DESIGN REVIEW  
RECOMMENDATION PROPOSAL

3400 Wallingford Ave N - 3014232  
3326 Wallingford Ave N - 3014233

Application Date:  
August 30, 2013

Burke Ave. N Elevation

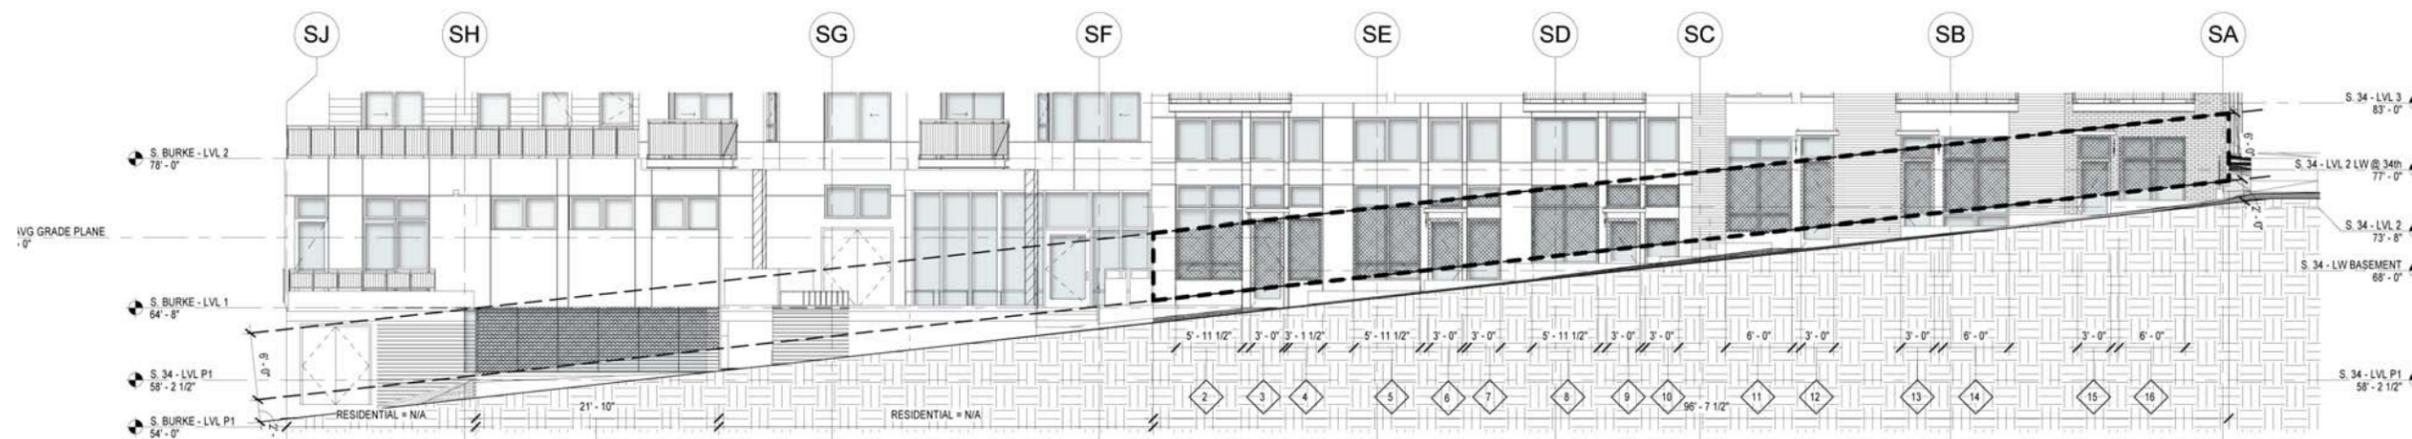
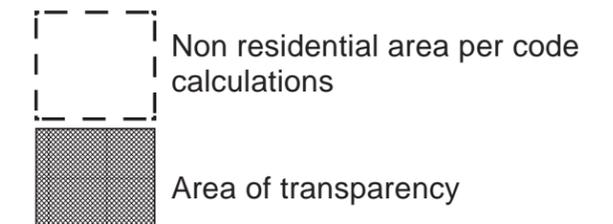
The live/work units should be treated similar to commercial storefronts.

Blank walls are minimized and corresponding transparency maximized along the length of the commercial façades. Elevations have been revised to add glazing and the departure request for blank wall has been rescinded.

See discussion of blank walls in D-2 above. The live-work units will have a significant amount of glazing to achieve the transparency goal. Elevations have been revised to add glazing and the departure request for transparency has been rescinded.

### D-3: Retaining Walls

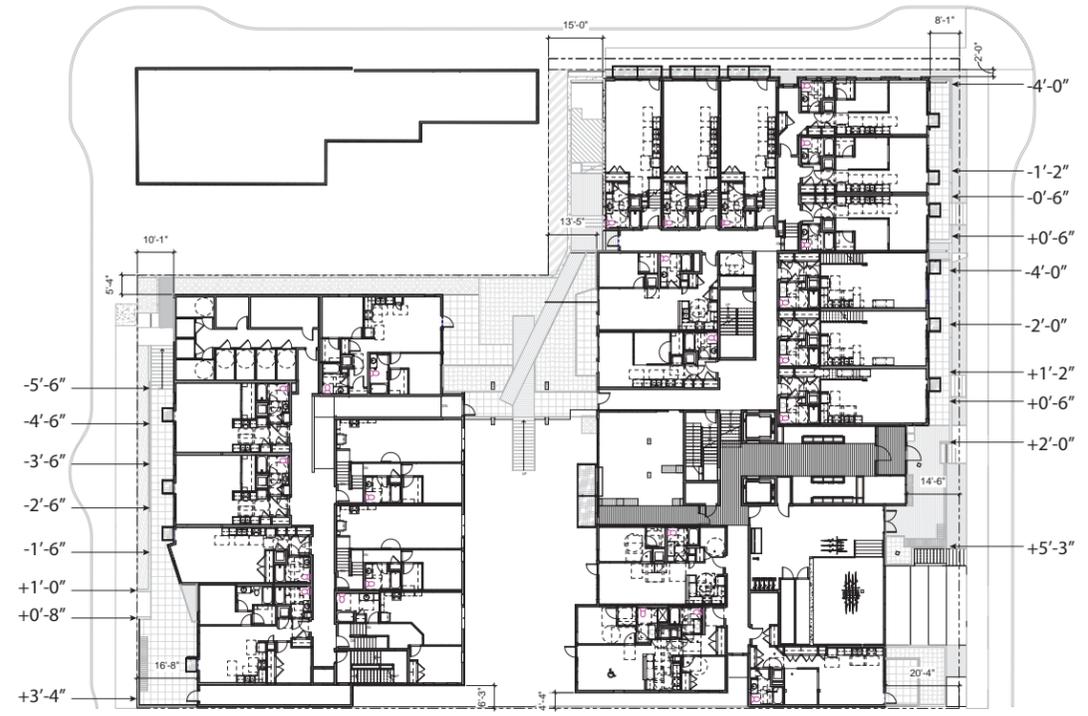
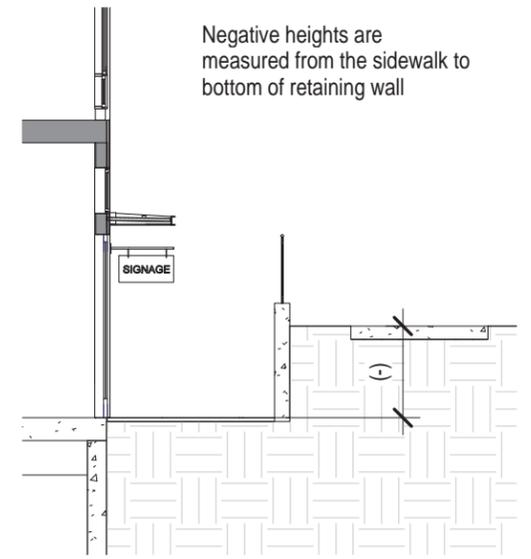
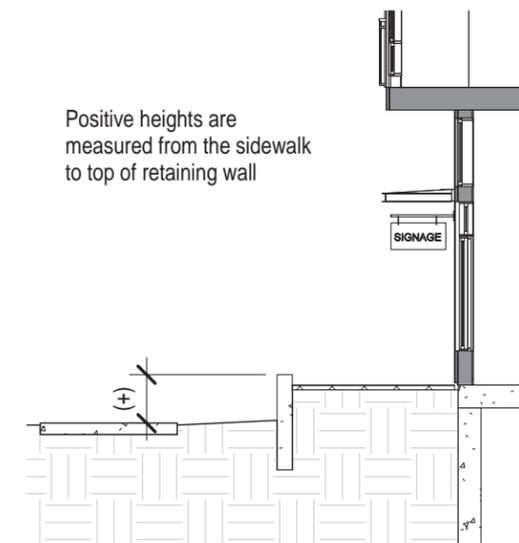
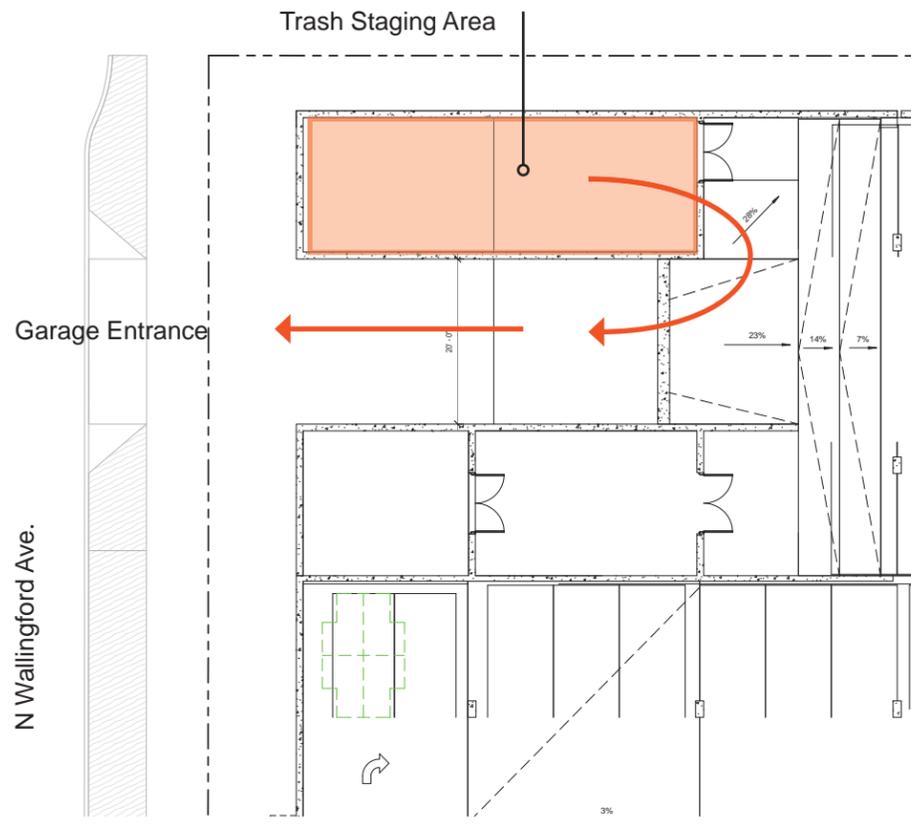
*Minimize the height of retaining walls.*

*Where retaining walls are unavoidable, a textured surface, inlaid material and/or sensitively designed reveal lines are encouraged.*

Retaining walls have been minimized. Where located they are treated with landscaping, textures or added materials.

### E-2: Landscaping to Enhance the Building and/or the Site

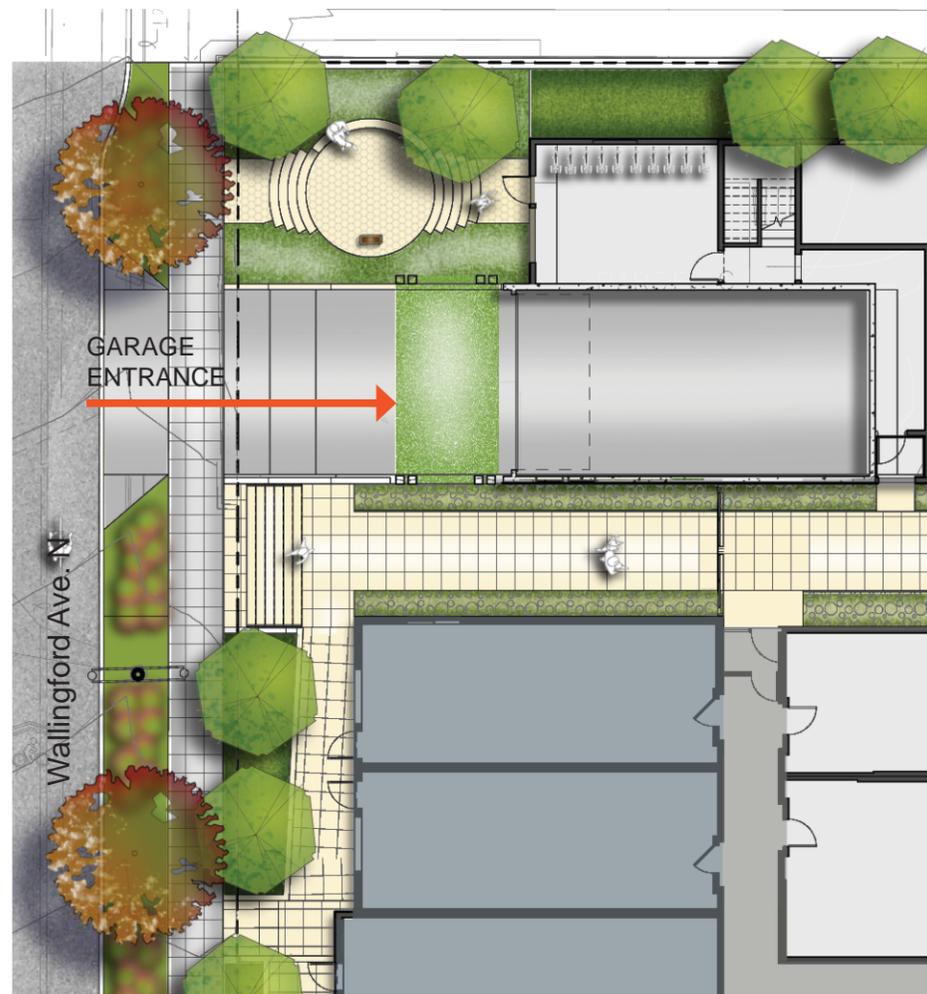
*Landscape plazas and open spaces at the rights of way which provide visual permeability into the site would enhance the connection between activity at streetscape and the sequences of open space within the complex. Other than the open space at N. 34th St on the north site, the views to the interior open spaces seem narrow and closed off. If a gate is to be considered for this open space along N. 34th St. in Option # 3, the gate should be set back from the sidewalk to create an eddy as an intermediary space between the public sphere and the private realm between the units. A landscape and placemaking site strategy should impact building forms, not merely decorating the edge of the site.*

The security gate at the "Boardwalk Courtyard" at the midpoint on 34th Street is recessed from the right of way to allow for public accessibility and gathering and seating areas. In addition, as shown in the DRB package perspective, this gate is mostly transparent. A metal frame allows visual access through the center of the two sites from outside in as well as from inside out. The gate utilizes elements of the wood boardwalk decking to transform vertically into low screens, benches and bike racks to provide functional security while still allowing visual transparency.

The bridges at the been also revised to allow for greater internal and external visual connection as described in C-3 above.
